8511 15th Avenue NE | DPD Project # 3006480 | Design Review Board Recommendation Meeting 2 | April 7, 2008

C.0 SUMMARY OF DESIGN REVIEW BOARD COMMENTS

PLANS : SITE PLAN BY UNIT TYPE D.1

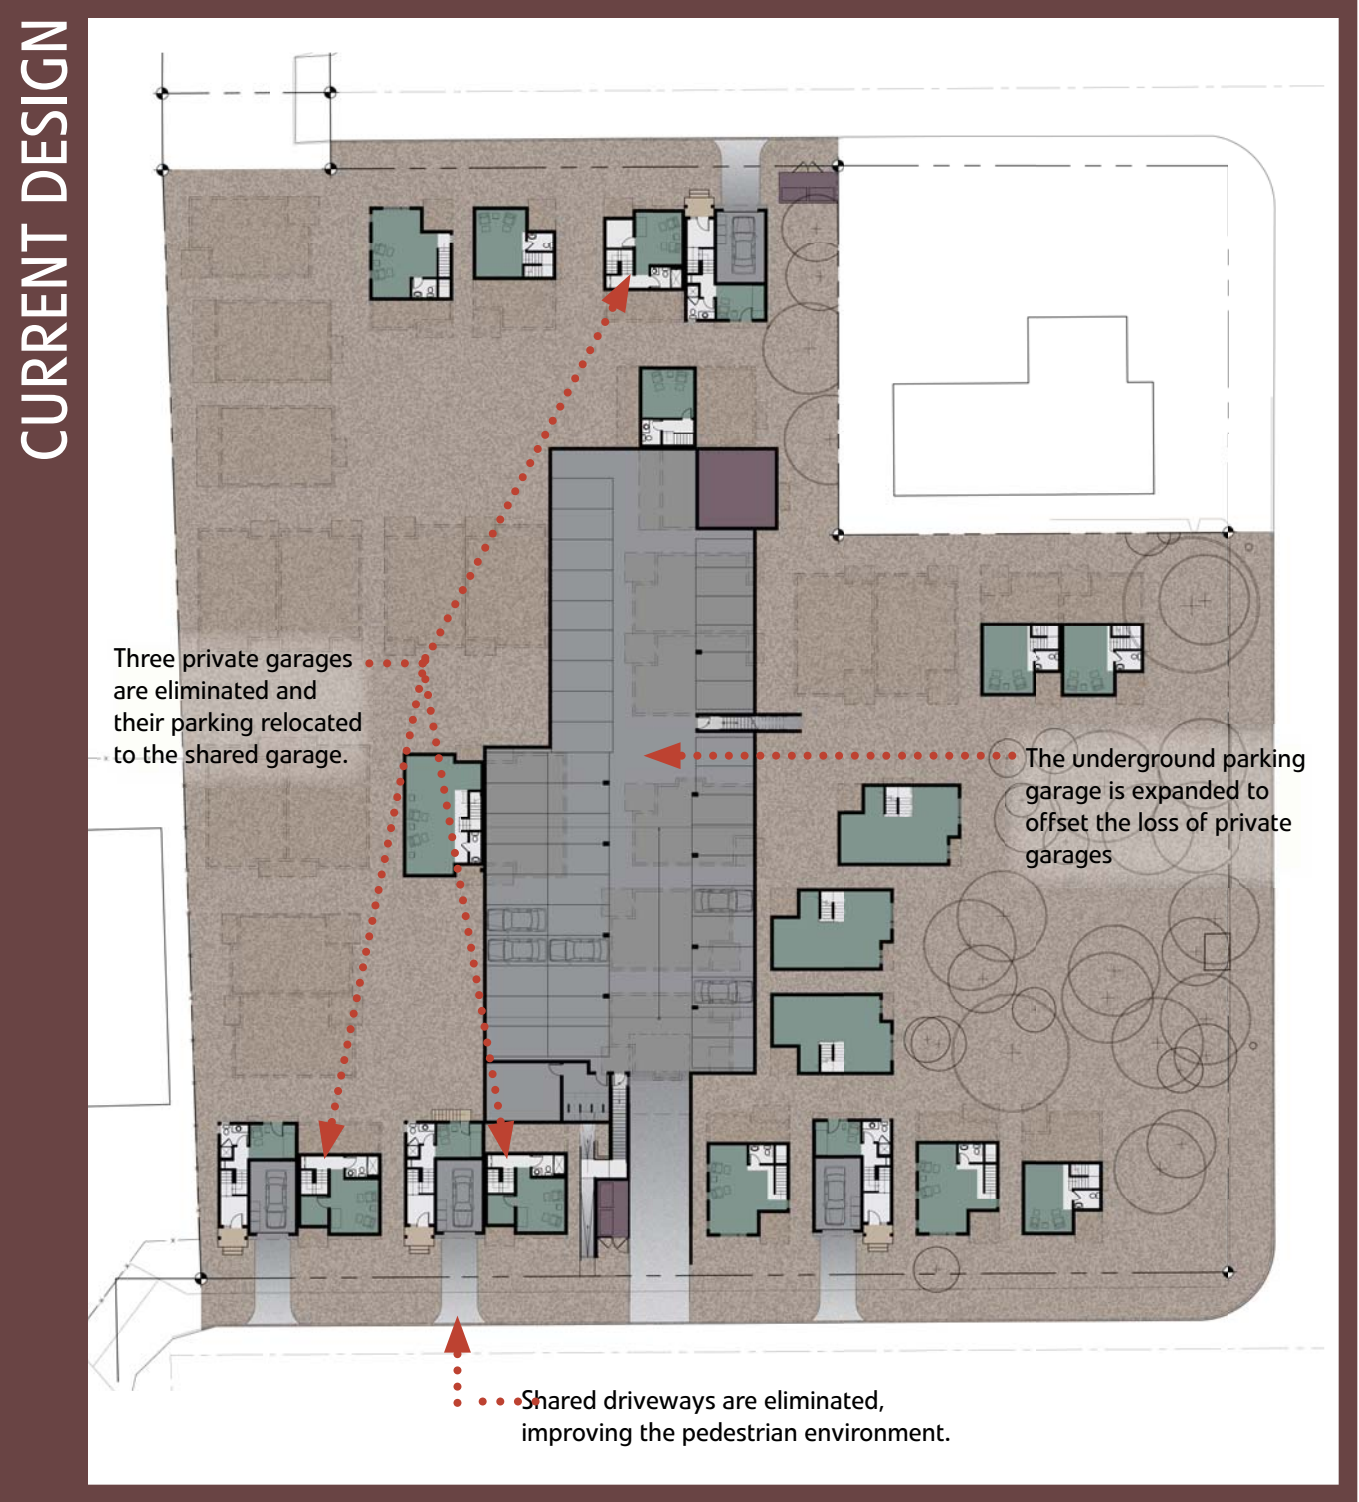
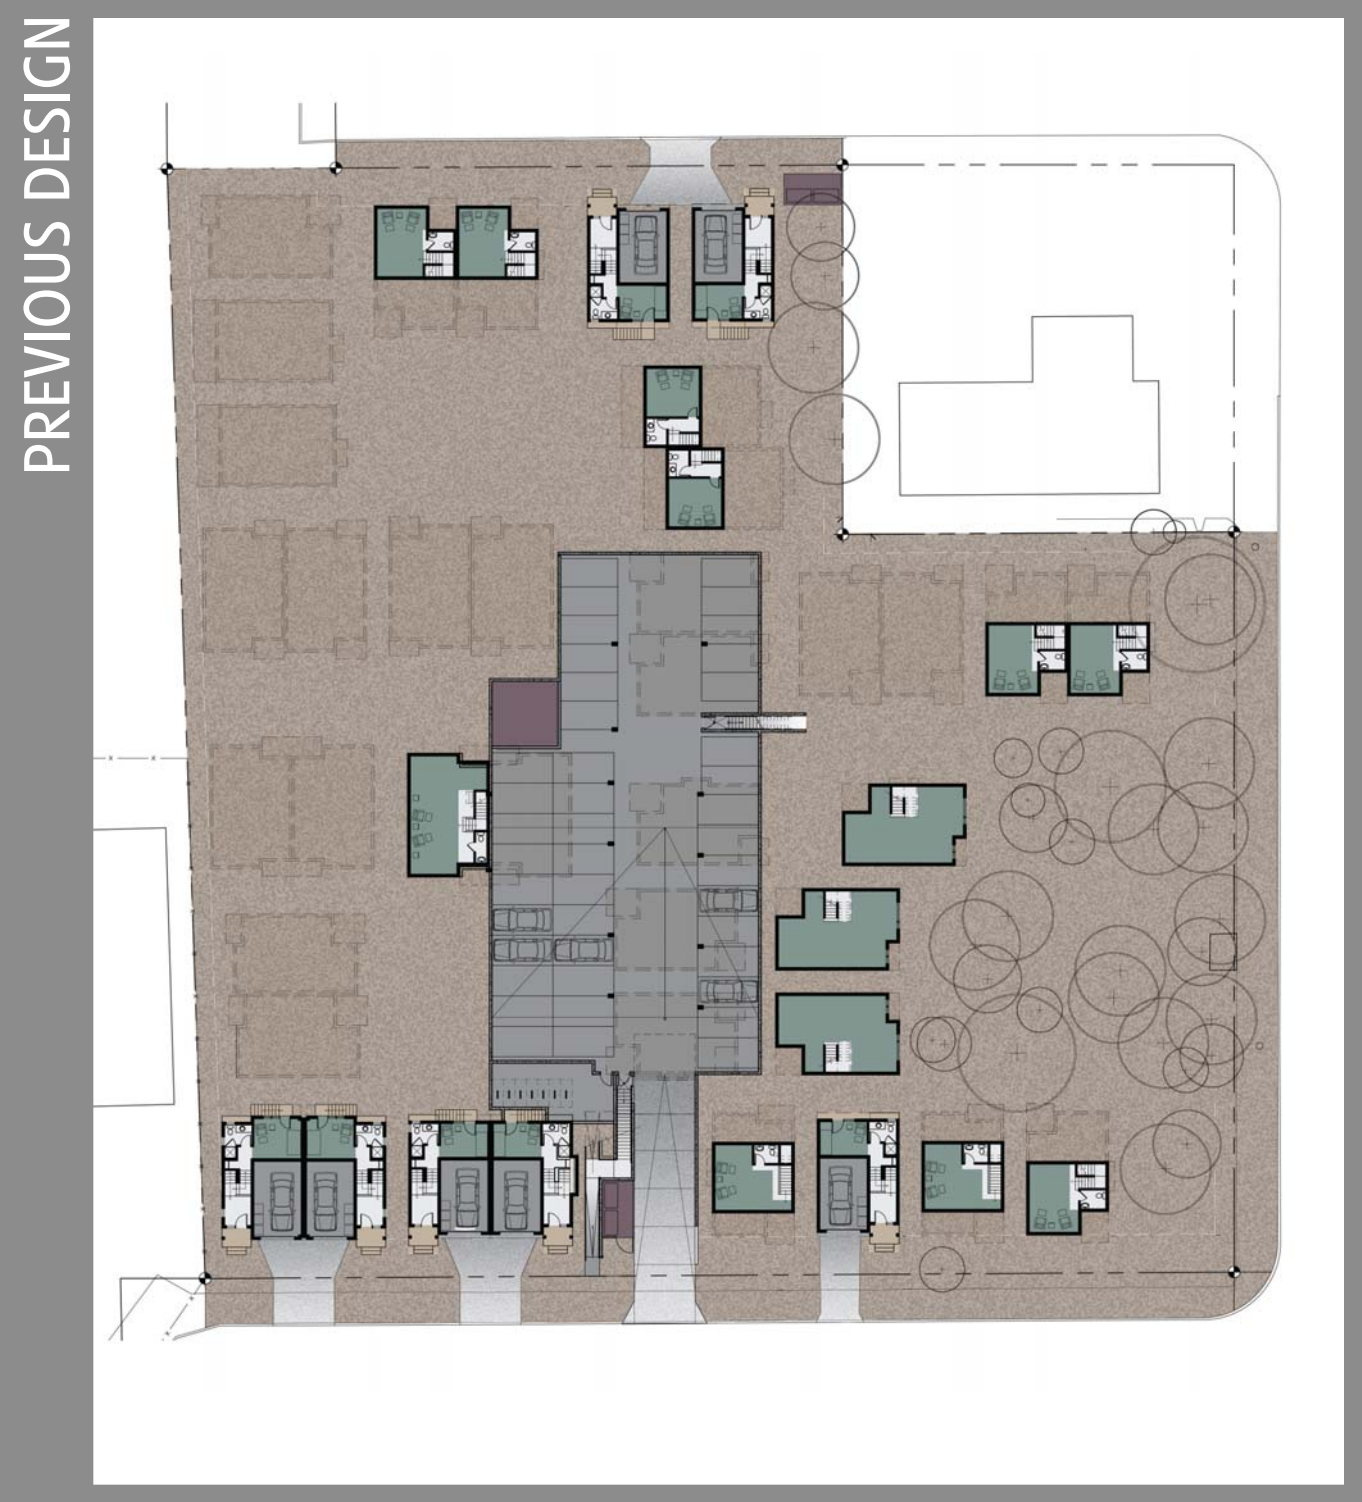
The Design Review Board thought the buildings’ ridge lines were too often parallel to the street, creating many instances where tall gable ends faced each other across narrow interior setbacks. They recommended variation in the side yard aspects with some roofs sloping into them to break up the ridge lines, reduce the buildings’ perceived height, and allow more light and air between structures.

Applicant’s Reponse: The latest design incorporates several revisions to create variety in the roof lines and to allow more light and air to the spaces between buildings. First, the most dramatic difference is in the overhaul of the duplexes with garages, discussed in more detail below. Second, the remaining units with garages now have roofs that slope toward a narrow setback (see pages E.0 and E.2). Third, the units that flank the path to the reservoir/park (Buildings 8 and 20) now have gable elements to break up the parallel ridgelines. Similarly, building 5 was replaced with a different unit type to balance the gable roof at the opposite end of that streetscape (see page E.4). Finally, efforts to revise the roof of the D and D Duplex units led to two elements at slightly different heights. While this does not result in a roof that slopes toward the narrow setback conditions, it does break up the roof lines, and provides necessary contrast to the units with gables that face front (see pages J.14 -J.17).

- Building 2 becomes the revised A.1_duplex, improving the views into the site.
- Buildings 3 and 4 are separated and building 4 becomes unit D to create more variety on the street front.
- Building 5 becomes unit A to add variety to the roof lines along the reservoir.
- Unit D.1 is eliminated and replaced at Building 22 with the revised A.1_duplex.

E.0 ELEVATIONS : NE 85TH STREET

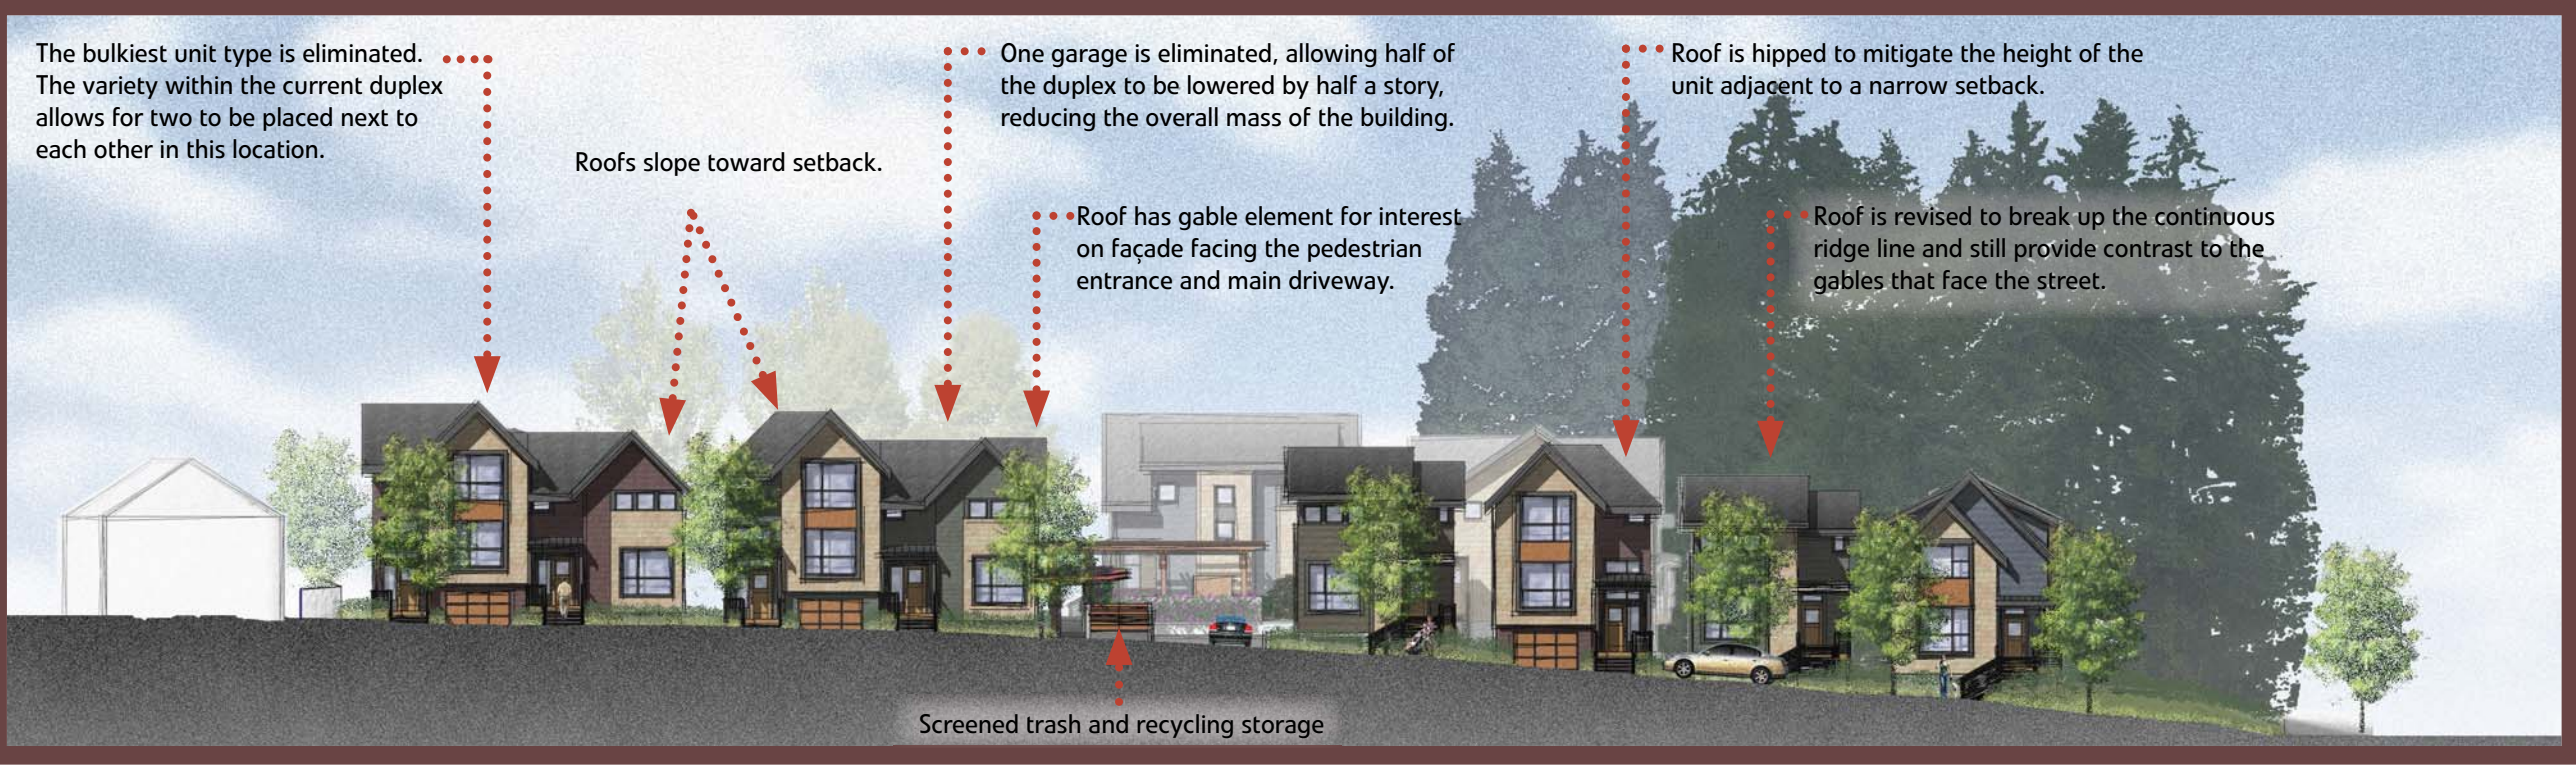
The Design Review Board thought the appearance of units along NE 85th Street and NE 86th Street should be closer in character to the single family areas. The fact that some of them are duplexes adds width, and the presence of garage levels adds height to the street facing units. They wanted some or all of those units to be lowered and their parking provided in the underground garage.

Applicant’s Reponse: The shared driveways of the previous design had resulted in tall, bulky buildings facing the street. This design has only one of the two duplex units with a private garage. The second unit is lowered by half a story, providing variety in the roofline and in the porches and awnings (page J.2 - J.3). The lowered portion of the duplex is positioned nearer pedestrian pathways where applicable. The roofs are revised to slope toward a narrow setback on at least one side. The roofs are also customized depending on their position on the site. For example, the roof of Building 23 that faces the path and driveway has a gable element to break up a static ridge line. The roof of Building 2 is hipped to mitigate the scale next to a narrower entrance to the site.

E.2 ELEVATIONS : NE 86TH STREET

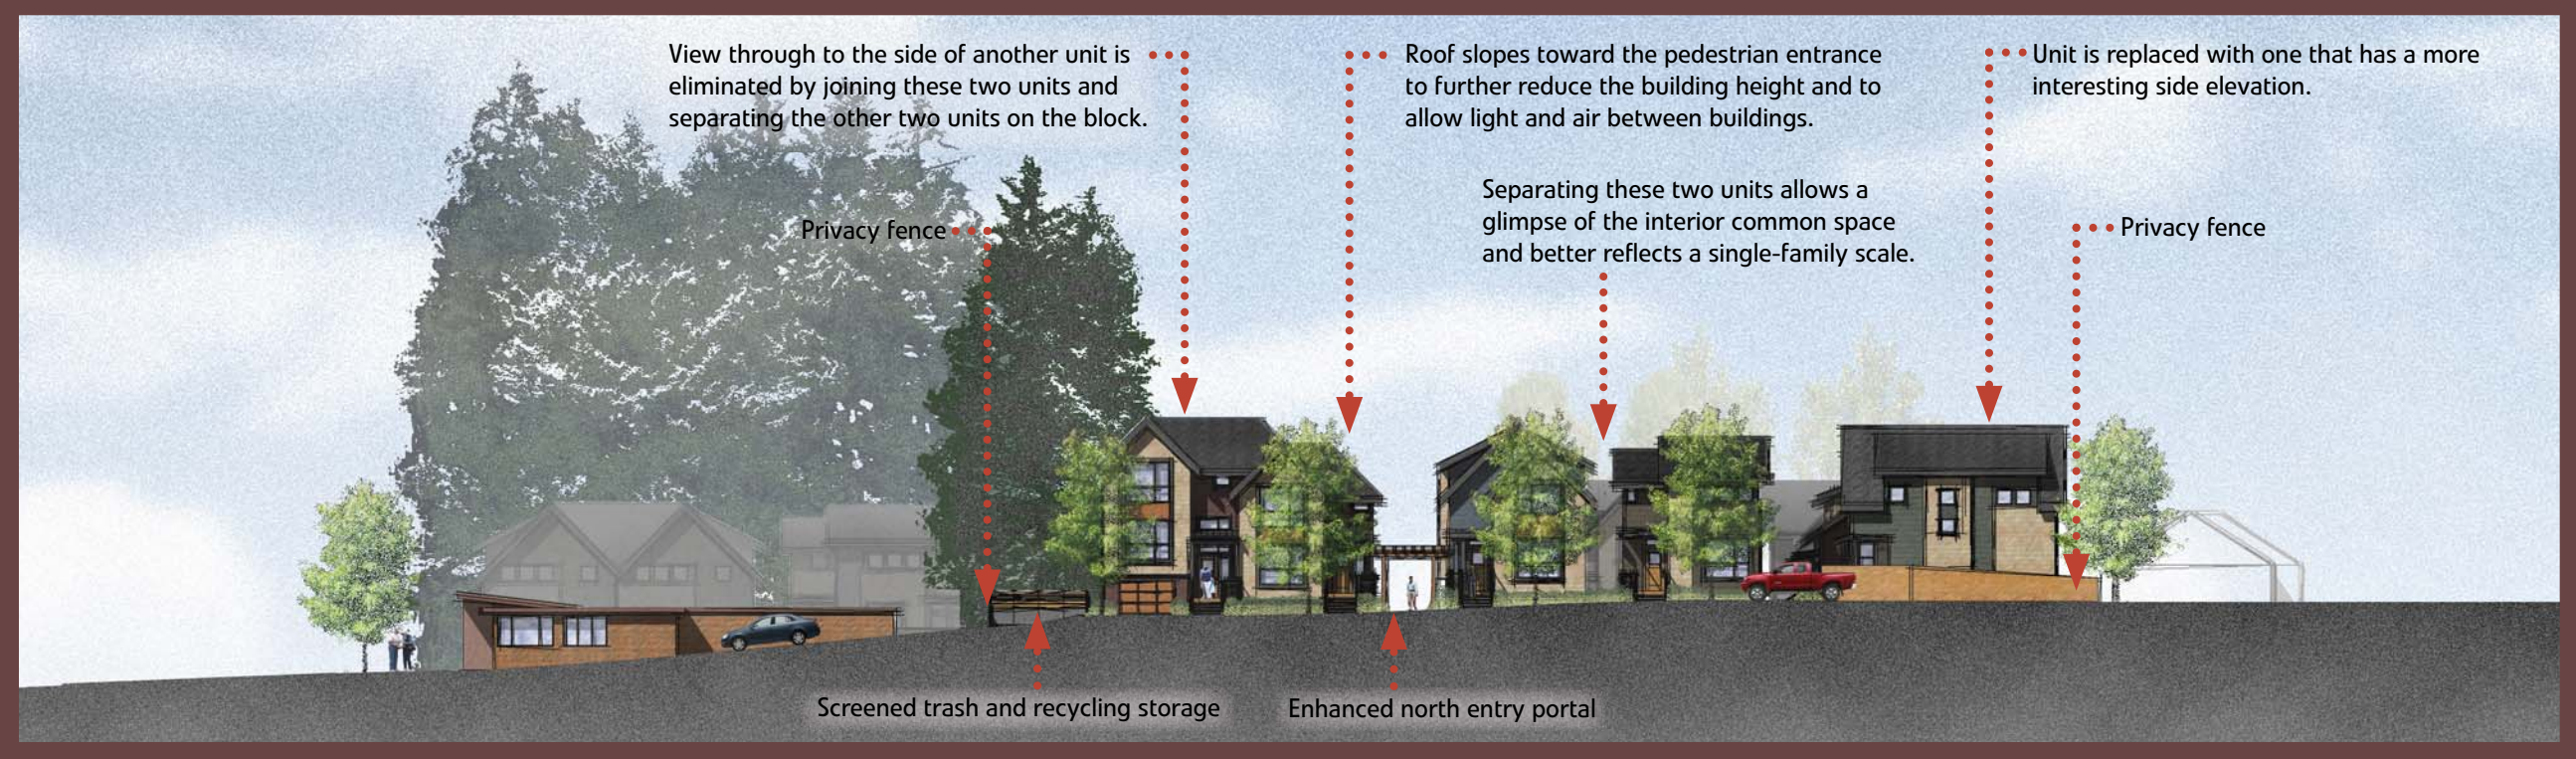
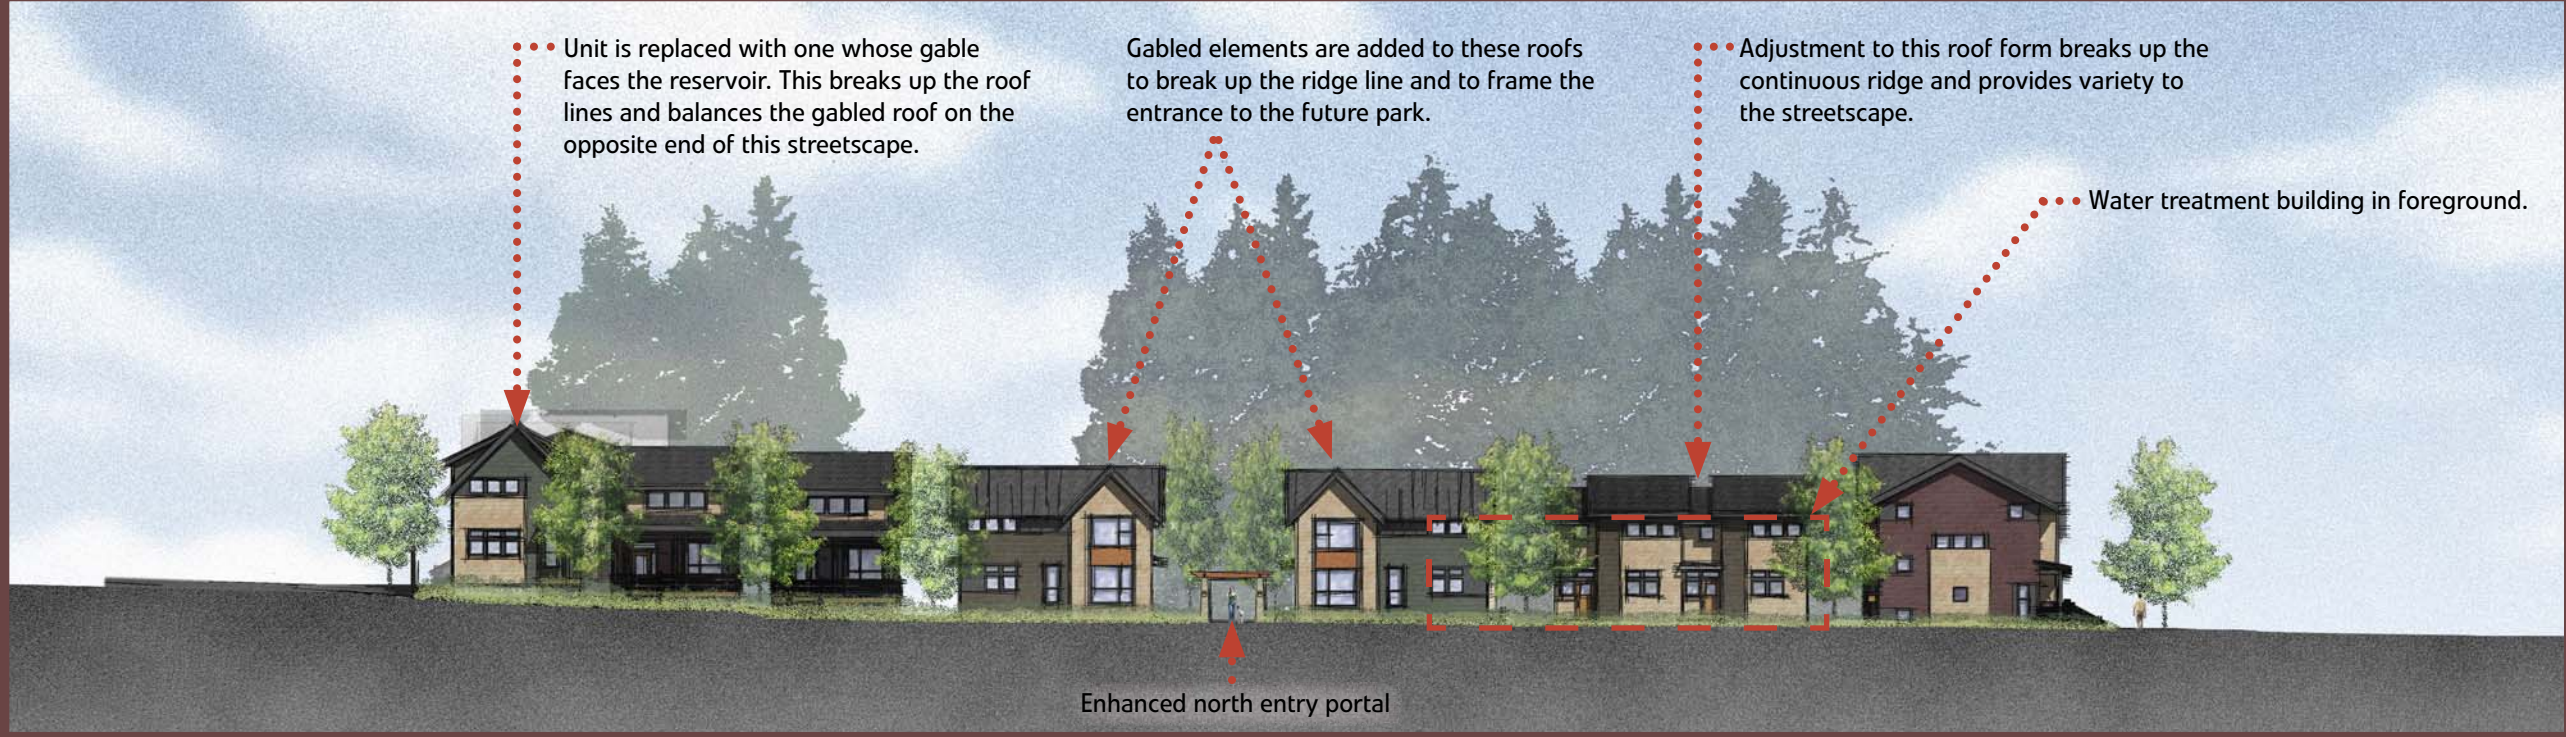
The Design Review Board would like to see more “porosity” or views into the interior of the site.

Applicant’s Response: Working within the restrictions of the site, the architect and applicant revised the buildings along 86th Street to join the two that had previously shared a driveway (Building 2) and to separate the other two dwellings on that block (Buildings 3 and 4). This move brings the entrance in line with the boardwalk and allows for views from one end of the site to the other. In addition, the view between units now includes the interior open space rather than the side of a building as in the previous design.
